# REQUEST FOR MULHOLLAND SCENIC PARKWAY SPECIFIC PLAN

8414 EDWIN DRIVE

MULHOLLAND SCENIC PARKWAY SPECIFIC PLAN DESIGN REVIEW BOARD

RESPONSE TO DESIGN REVIEW COMMENTS

EXISTING WALL SECTION  
 1/4" = 1'-0" 1

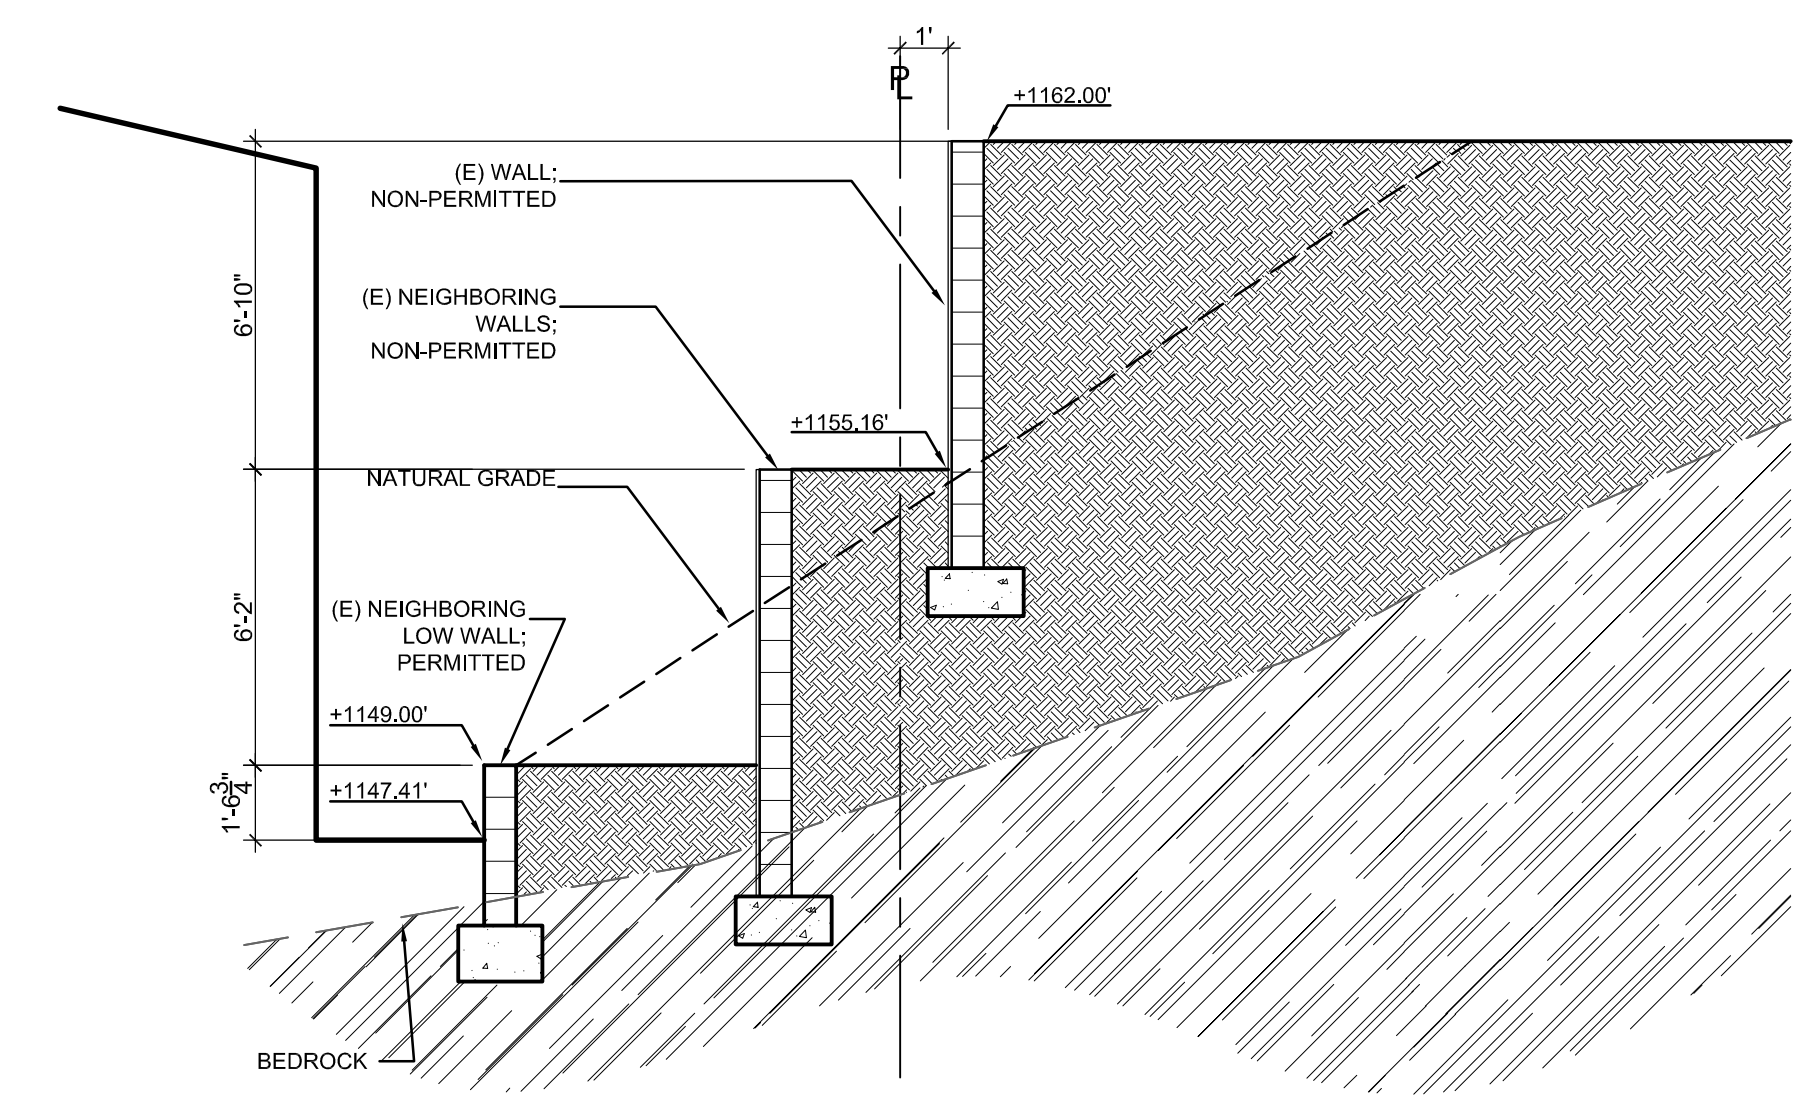
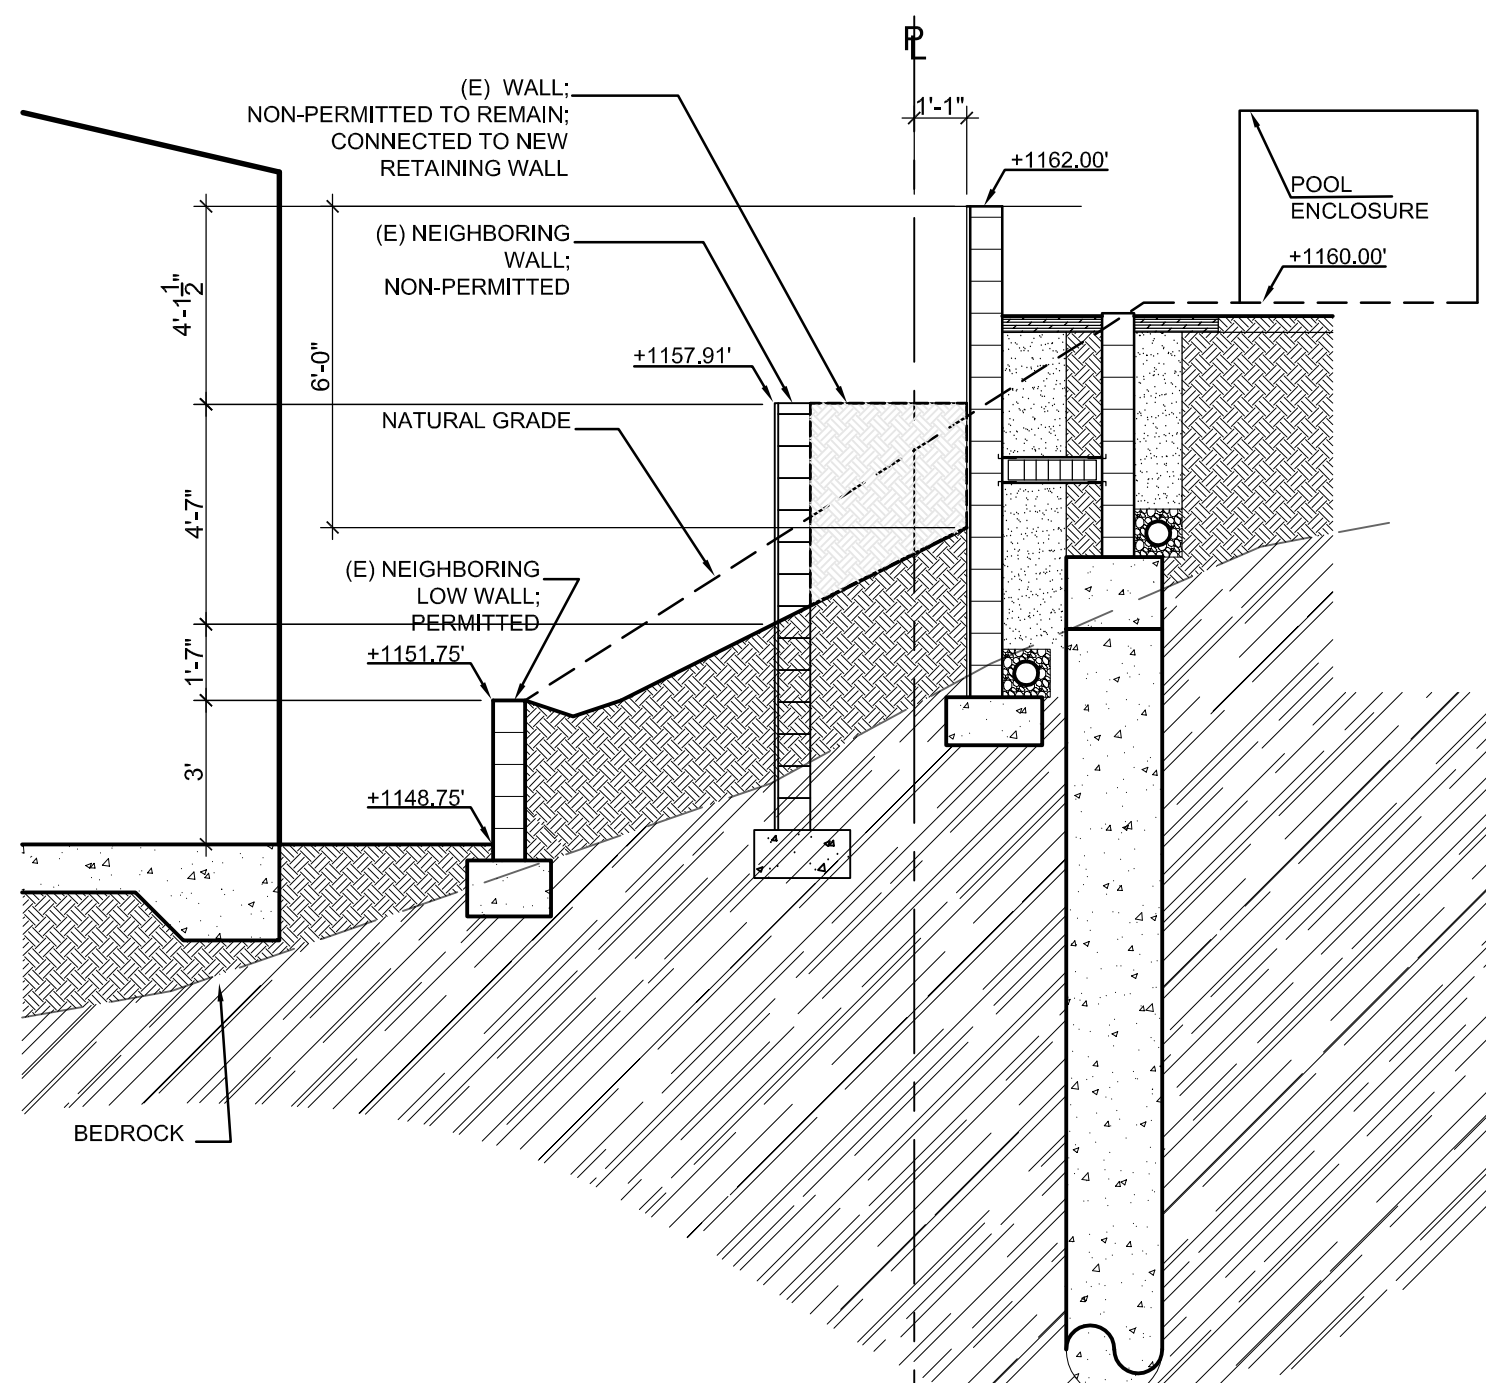
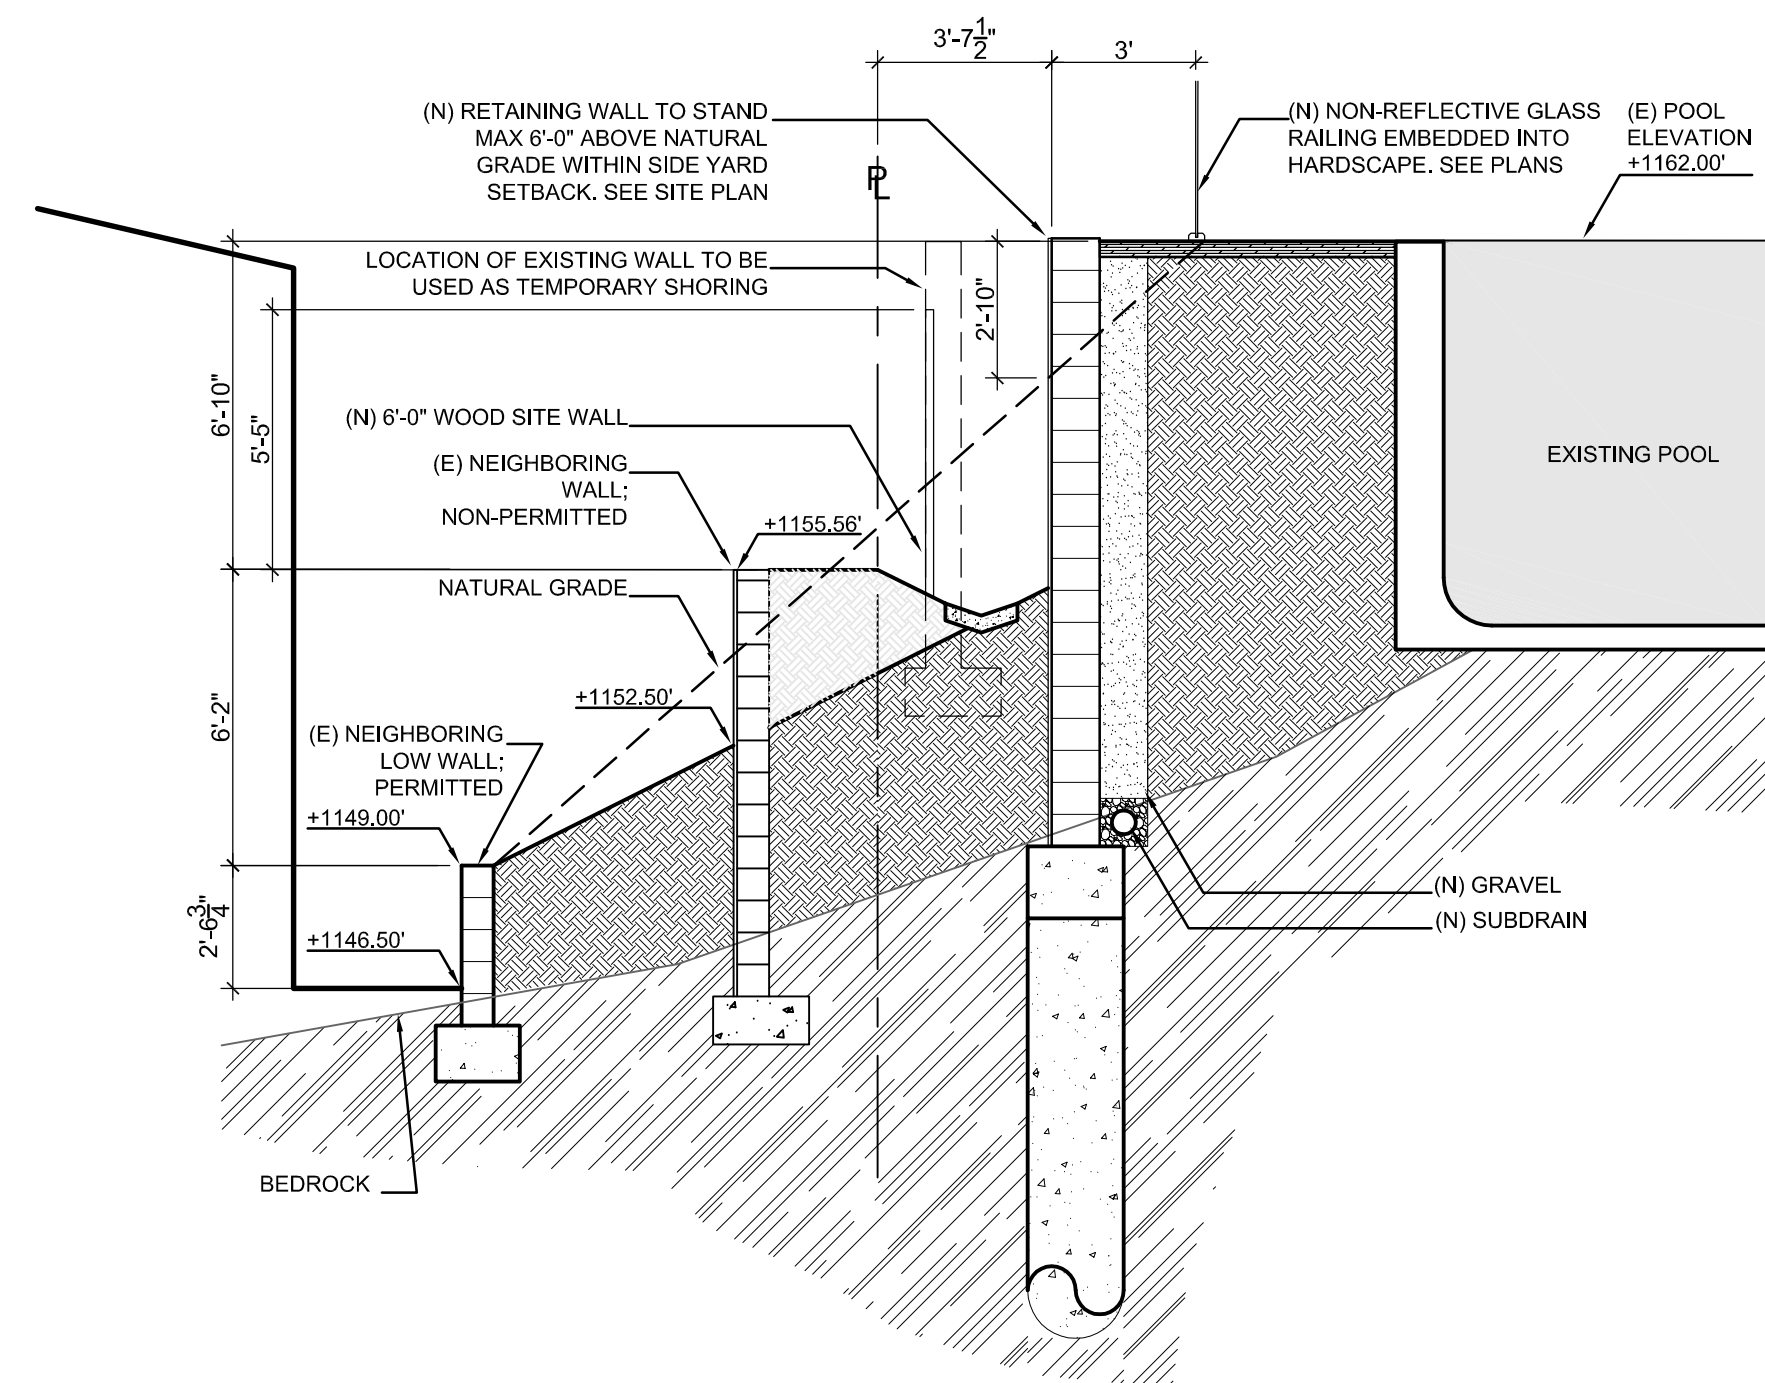
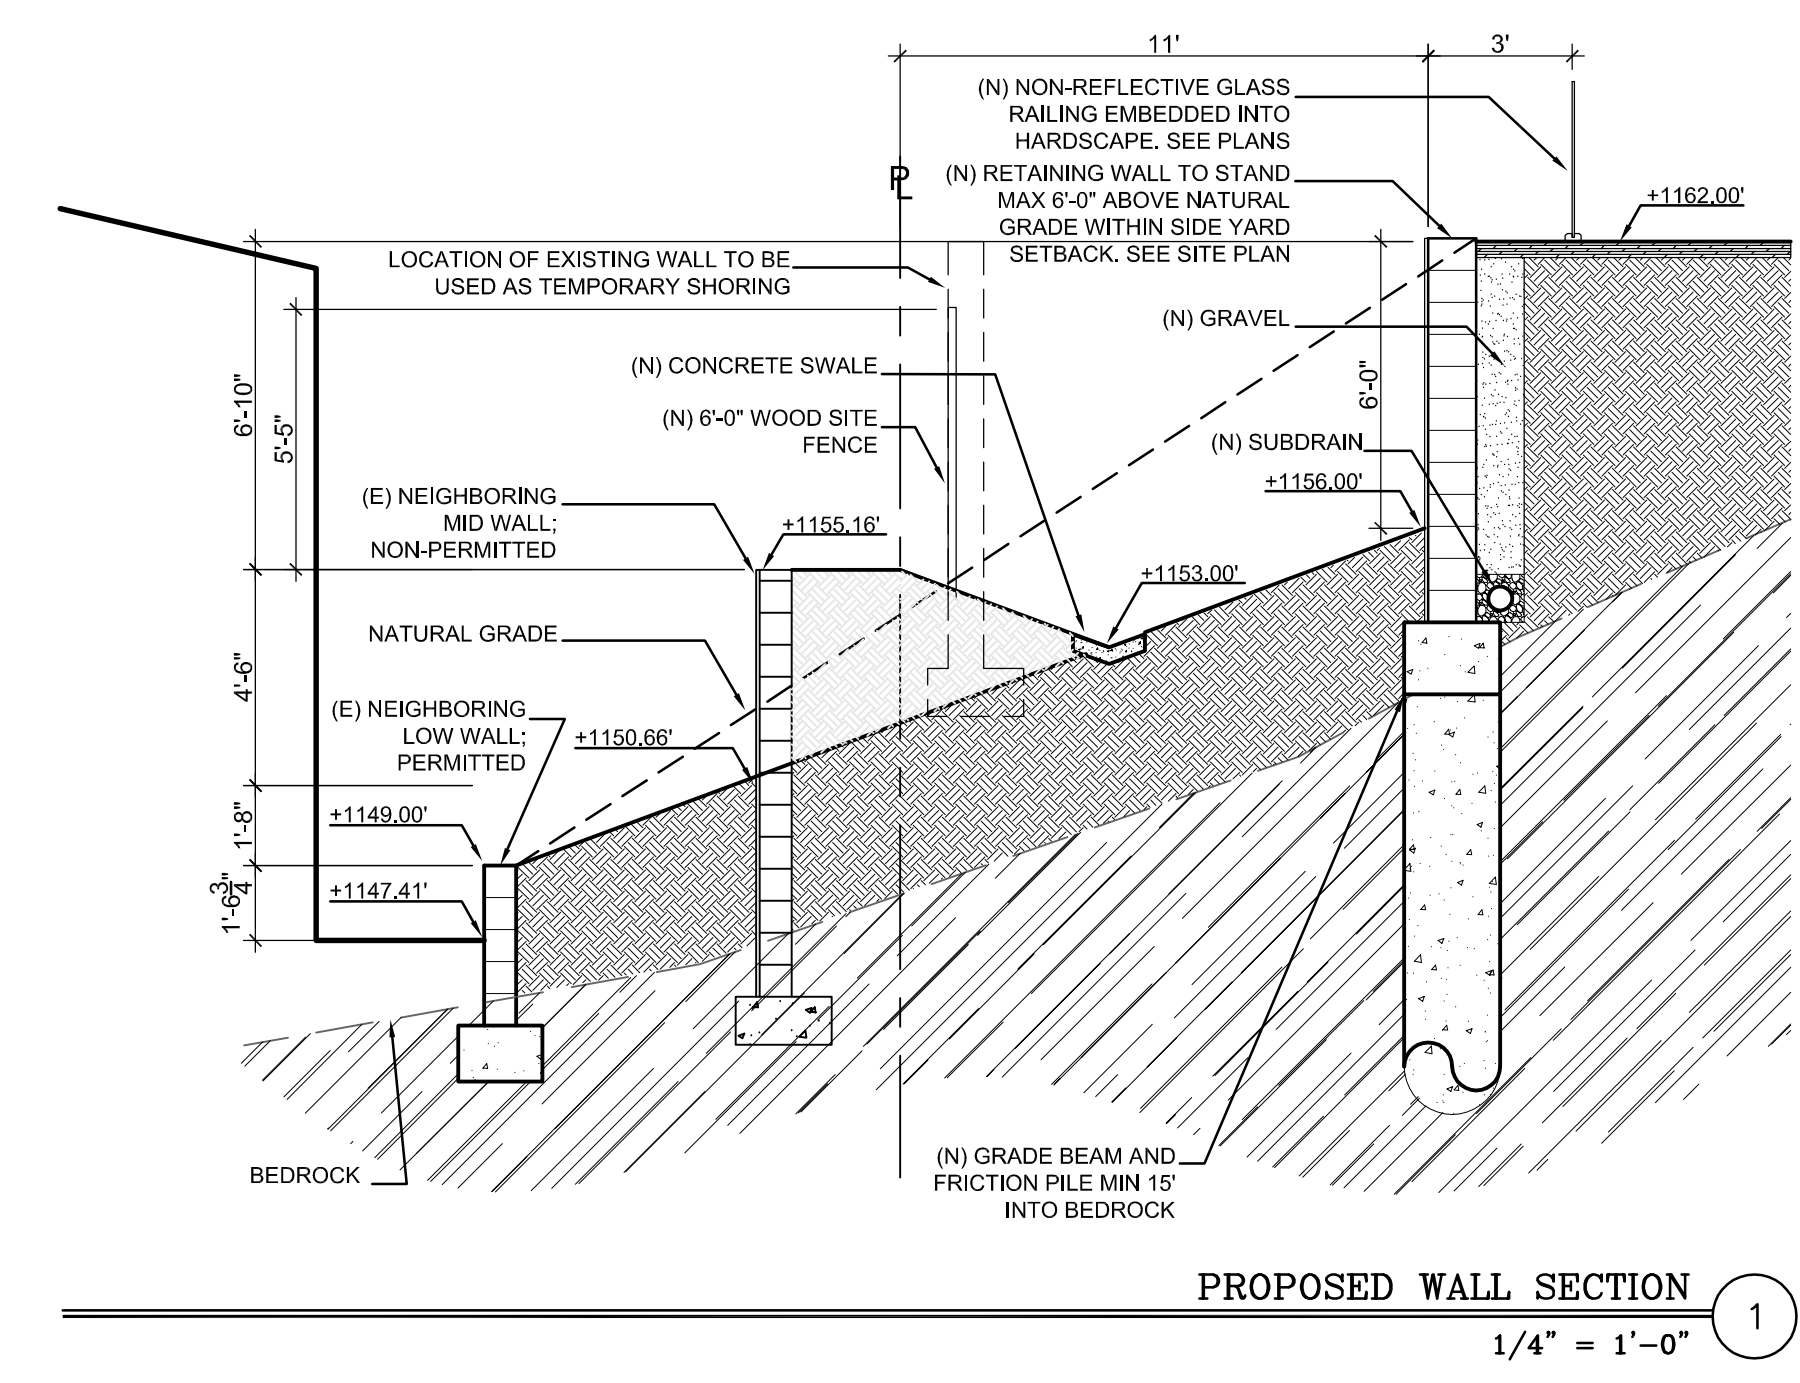
- Show 3 sections: prior, existing, and proposed of wall at property line for a total of 9 drawings like those sections shown on pg. 28

The major concern from the Design Review Board was making sure the project retaining wall design is "independent" downhill to the adjacent neighboring property. In order to ensure safety, we are designing retaining walls, by-right, using LADBS regulations, zoning code, and the Mulholland Specific Plan. Major caisson construction will allow all grade levels located at 8414 Edwin Drive to remain independent of the adjacent site and street level.

- 1 THE NINE NEW SECTIONS ON PAGE 28A ILLUSTRATE OUR PROPOSITION CONFORMING TO THE SPECIFIC PLAN GUIDELINES WHILE RETAINING INDEPENDENCE BETWEEN OUR SITE AND ANY NEIGHBOING PROPERTIES.
- 2 ANY NEW RETAINING WALLS WILL BE CONCEALED BY DENSE PLANTING, INCLUDING TREES, SHRUBS, AND VINES AS PER OUR PROJECT RENDERS ON PAGE 23 AND LANDSCAPE DRAWINGS
- 3 OUR NEW PLANT LIST CONSISTS OF AT LEAST 75% PREFERRED PLANTS.
- 4 SECTIONS ON PAGE 28A CONFIRM THAT NEW RETAINING WALLS DO NOT EXCEED 10 FEET IN HEIGHT AND CONFORM TO THE GUIDELINES OF THE SPECIFIC PLAN.
